Stone Brook Academy
(previously known as Prestmore Academy)
Site Selection Log

SITE 1
01/18/2017

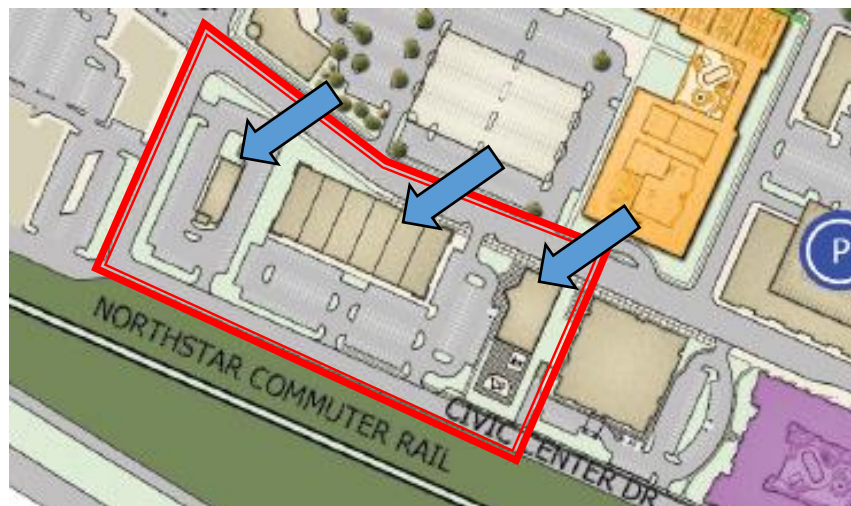
- Water/ sewer service have been pre-determined, ahead of development, for the larger 5-acre site. Stubs have been placed in the proposed Yolite row/ intersection, on Sunwood Drive; and stubs have been placed about midway within the remaining portion of the site.

- i. The location of these stubs would allow for services to be provided to the proposed Stone Brook site, and the two remnant lots. In summary, the pre-determined location of stubs is not a barrier to this proposed Stone Brook site location.

E. WELL LOCATED ON LARGER PARCEL, Staff Development Review Comments

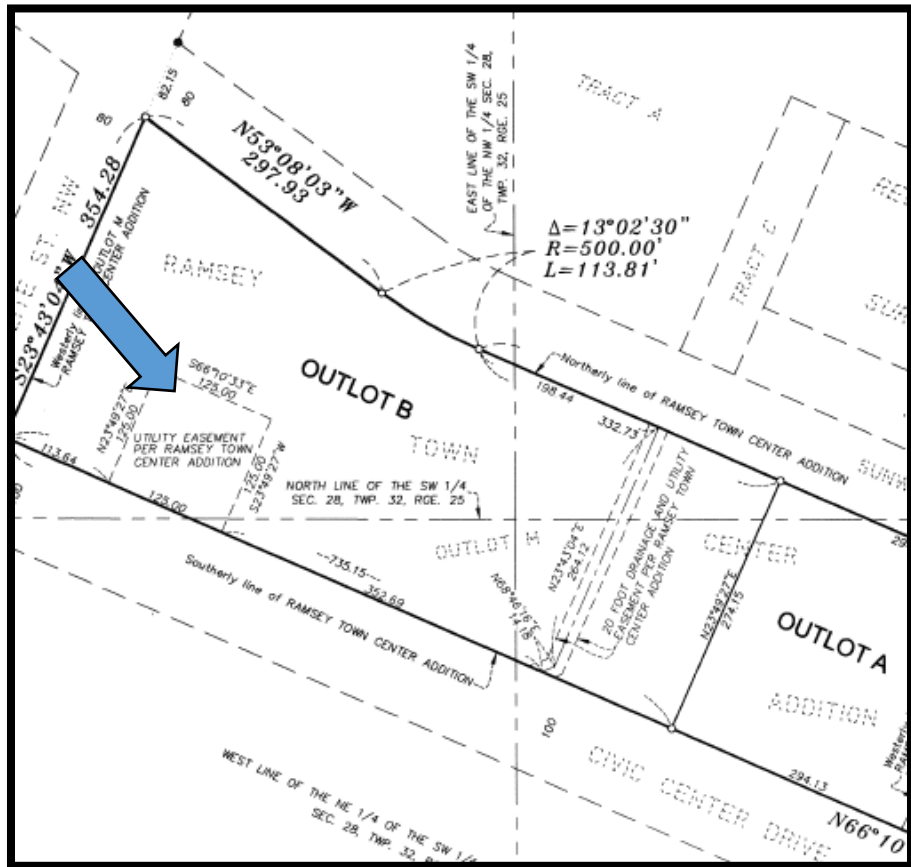
- There is a public well in the SW corner of the larger 5-acre site. This well includes a 125' easement. The well/ easement is *NOT* located on the proposed Stone Brook site. However, it will affect the 3-acre remnant lot (located west of the 1-acre Stone Brook lot). Generally speaking, when the 3-acre remnant site is developed, the well easement it will restrict potential building layouts. Buildings can't be constructed over the easement—however, parking and greenspace may be allowed. Staff wanted to simply note this item. This will be an issue to deal with, regardless of Stone Brook.

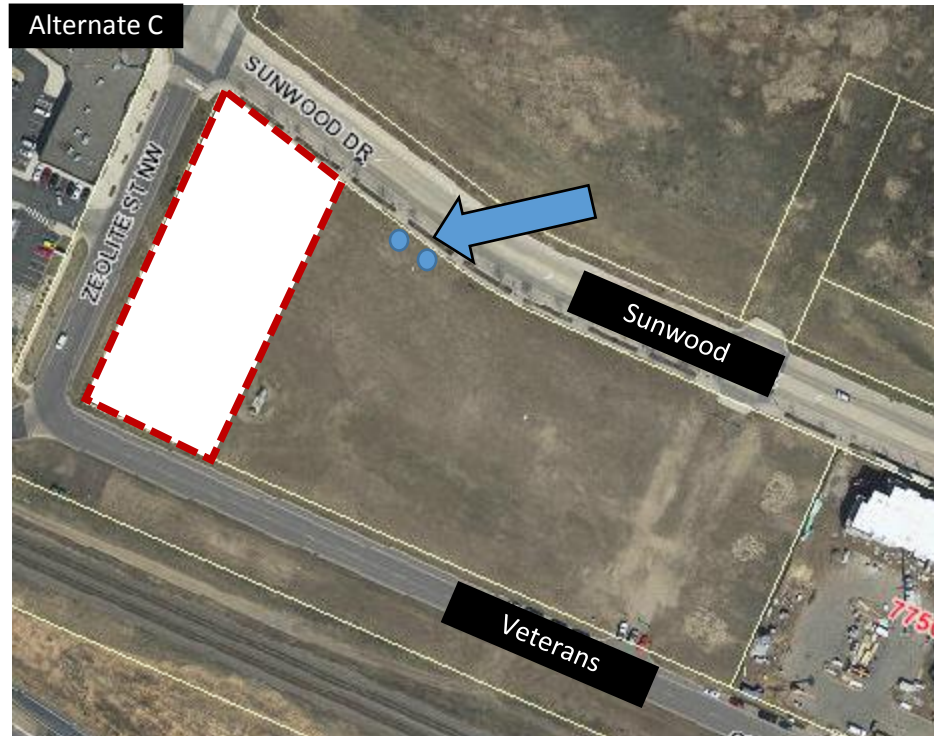
Stone Brook Comments:

- Alternate A is physically too narrow, and too small to allow for what Stone Brook wants to accomplish (10,000 sf building plus a 1,500 sf playground). This was determined by their developer/ architect.
- Additionally, Stone Brook wants the focal point/ front of their building to be pressed up against Sunwood Drive (to be prominent). This layout would physically force the focal point of their building to be located central to the site (and the side of their building to be pressed against Sunwood). They feel this doesn't meet the "theme/vision" of The COR.
- Lastly, Stone Brook needs a round-about drop-off at their entrance—which requires a minimum 100' of site width (this remnant lot site is roughly 85' wide). Ideally, they want to have at least a 185' wide site.

Stone Brook Comments:

- Alternate B rendered identical comments from Stone Brook (compared to Alternate A).
- Although they are able to pick up additional land to the south, the shape/ constraints of the lot still make it undesirable (as they want to front Sunwood with their building, on the north). The shape of this lot creates issues with their desired site layout.

Stone Brook Comments:

- Alternate C works for Stone Brook. They understand the public well issue, and are willing to work around. This is not their #1 option—but would be willing to consider.

- Unfortunately, water/sewer stubs are located central to this site. Therefore, staff is concerned about how this user will access water/ sewer. One option is to punch into Sunwood Drive for new stubs (not recommended by staff). Another option is to run utilities internal to the property (also not recommended by staff).

- RE the water/ sewer stubs--the easy/ desired route would be to require this lot to be taken down all at once, or at least require the Stone Brook lot to extend all the way out to the utility stubs. In that scenario, Stone Brook would be picking up nearly 2x the land they need (which they would oppose—as would staff recommend against).
